10GBASE-CX4

Draft 4.2+ Physical Layer Specifications

July 2003

10GBASE-CX4- Compliance Channel Insertion loss:

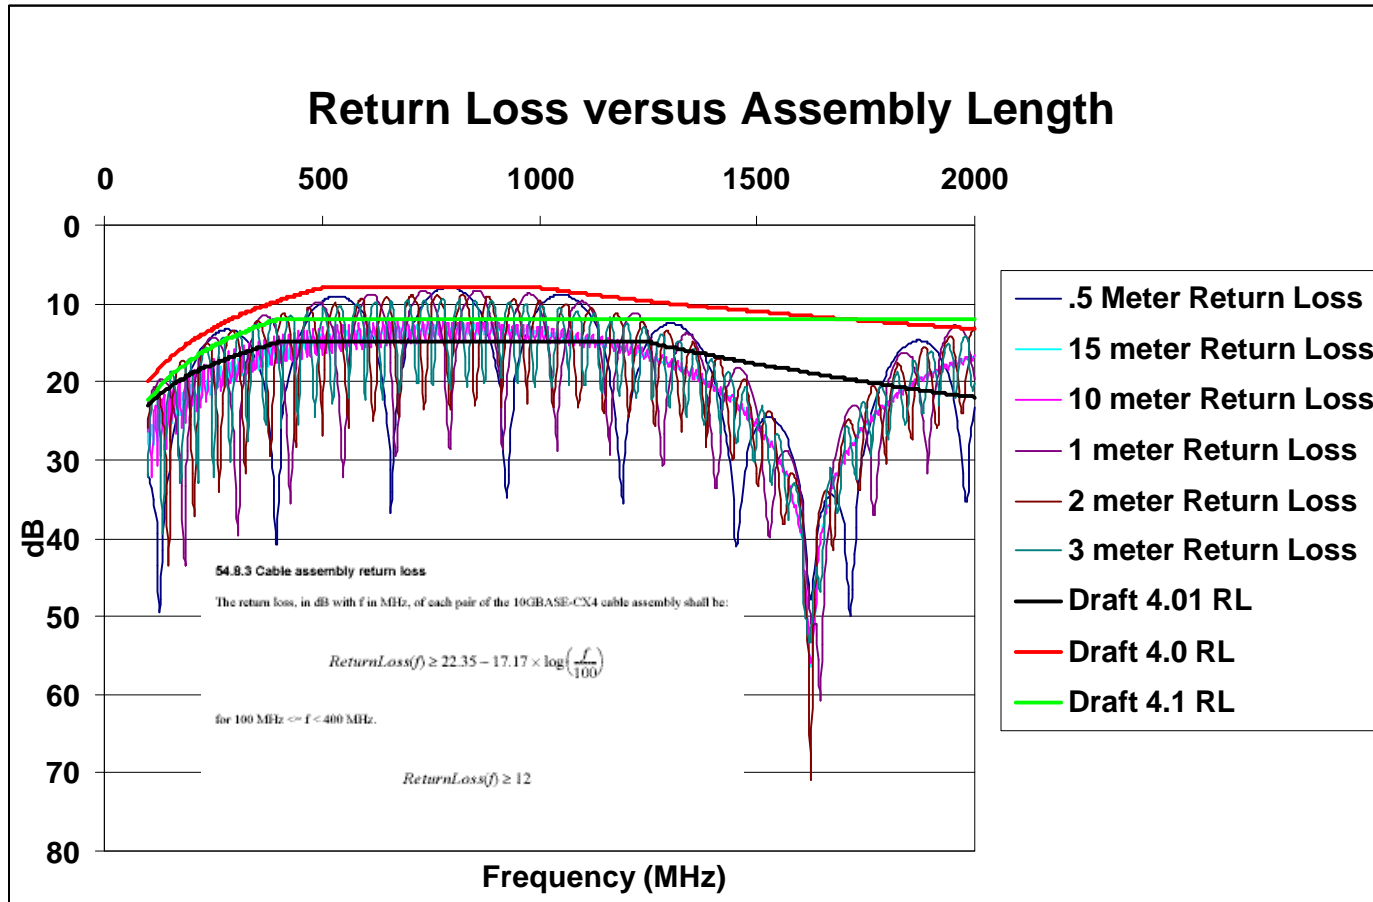
Summary 4.1 <-----> 4.2

- Insertion loss .5 dB better
- MDNEXT 1 dB better
- ELFEXT 1 dB better
- MDELNEXT 1 dB better

Component	Insertion Loss (dB)
Cable	15 dB @ 1.56 GHz
(2) Connectors	$2 \cdot (.012659 \cdot \sqrt{f})$ @ 1.56 GHz = 1.0

The insertion loss of each pair of the CX4 cable assembly shall be:

$$\text{Insertion loss} \leq \left(.2629 \cdot \sqrt{f_k} + .0034 \cdot f_k + \frac{12.7632}{\sqrt{f_k}} \right) \text{ Frequency (MHz)}$$

CX4 Assembly MDNEXT Limit (Draft 4.1 <----> 4.2)

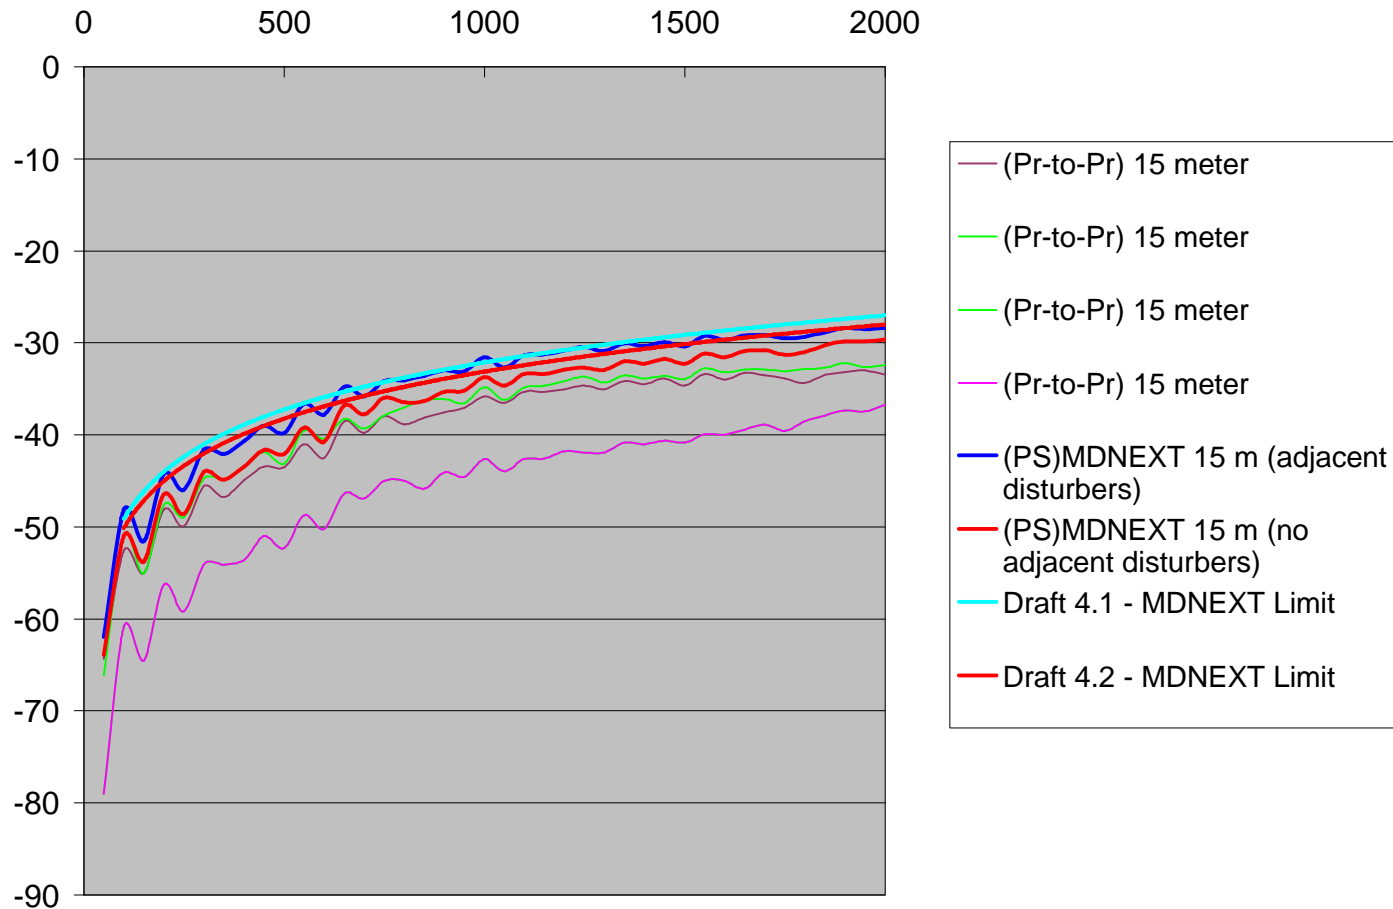
The MDNEXT loss between any two channels of a CX4 link segment shall be at least: $27 - 17 \cdot \log_{10}(f/2000)$ <-----> $28 - 17 \cdot \log_{10}(f/2000)$

CX4 Assembly ELFEXT Limit (Draft 4.1 <---> Draft 4.2)

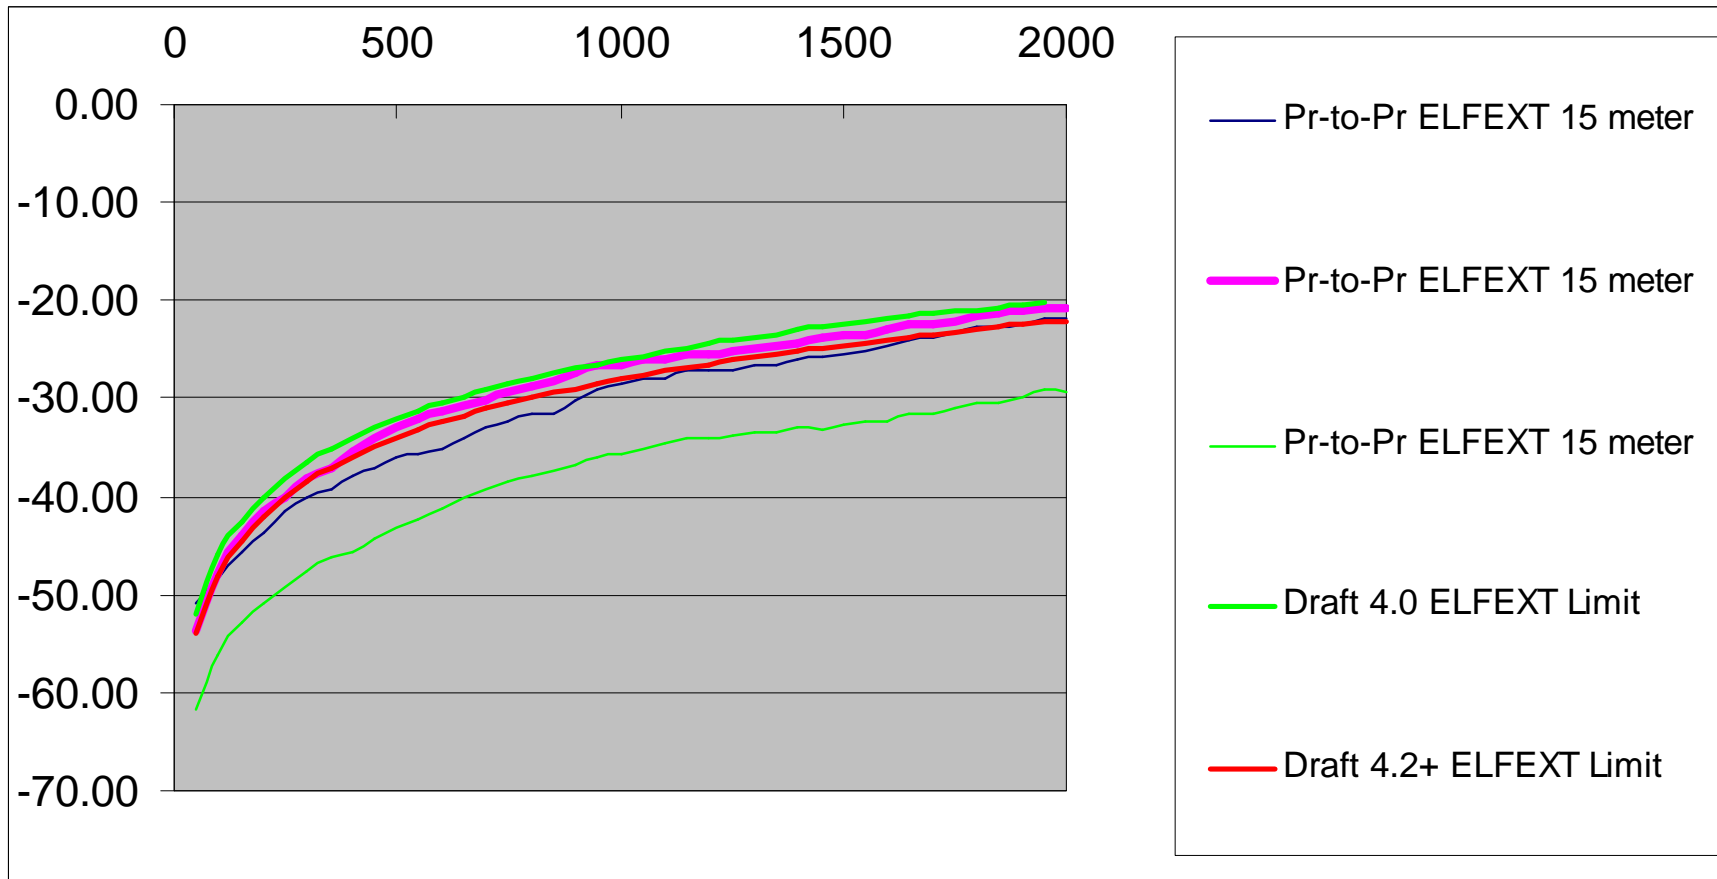
The worst pair ELFEXT loss between any two channels of a CX4 link segment shall be at least: $20 - 20 \cdot \log_{10}(f/2000)$ <-----> $21 - 20 \cdot \log_{10}(f/2000)$

CX4 Assembly MDELXFEXT Limit (Draft 4.1<----> Draft 4.2)

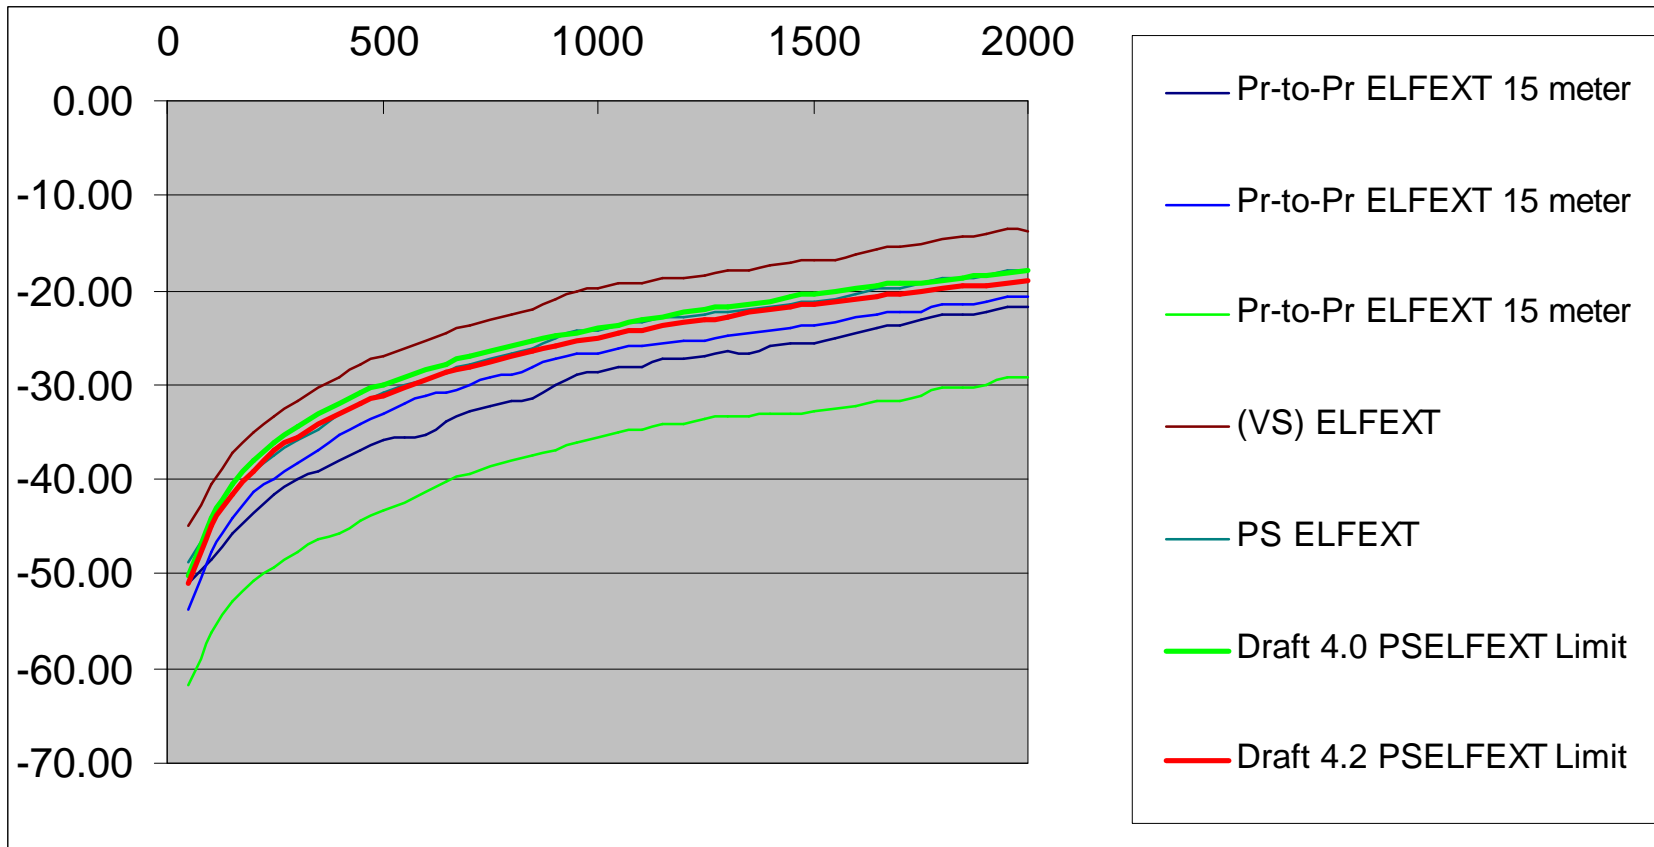
The PSELFEXT loss between any two channels of a CX4 link segment shall be at least: $18-20 \cdot \log_{10}(f/2000)$ <----> $19-20 \cdot \log_{10}(f/2000)$
